**REQUEST**

Current Zoning: B-1 (neighborhood business) & TOD-M (transit oriented development- mixed use)  
Proposed Zoning: TOD-MO (transit oriented development- mixed use, optional)

Approximately 0.529 acres located on the west side of South Boulevard, between E. Kingston Ave and East Boulevard.  
(Council District 3 - Mayfield)

The petition proposes to allow the reuse of existing 18,946 square foot building and vacant lot to allow all uses in the TOD-M district and 10,700 square feet for a patio and outdoor entertainment space.

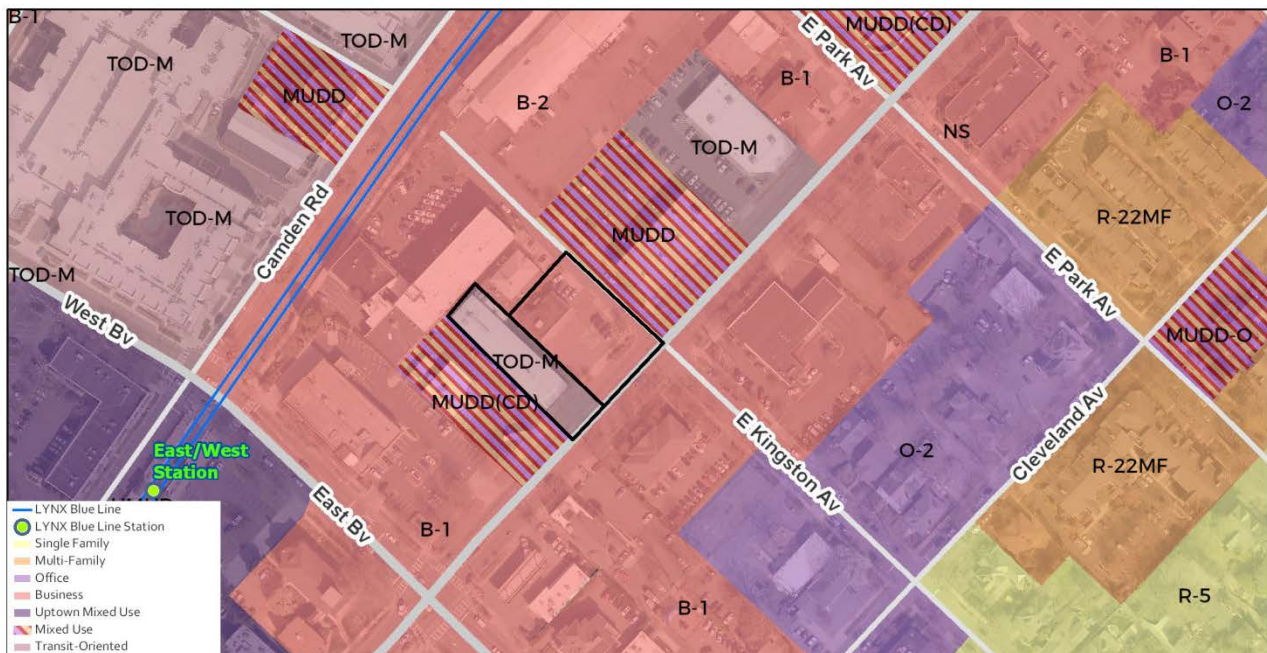
1. Label and list square footage of the existing building.
2. Label and show proposed dumpster location.
3. Provide detail of proposed four foot tall wall.

4. The petitioner should revise site plan notes to remove note "b" under Transportation. The petitioner is responsible for utility relocations/modifications caused by the development of the site. This includes existing (not proposed) traffic and pedestrian signals if impacted.
-
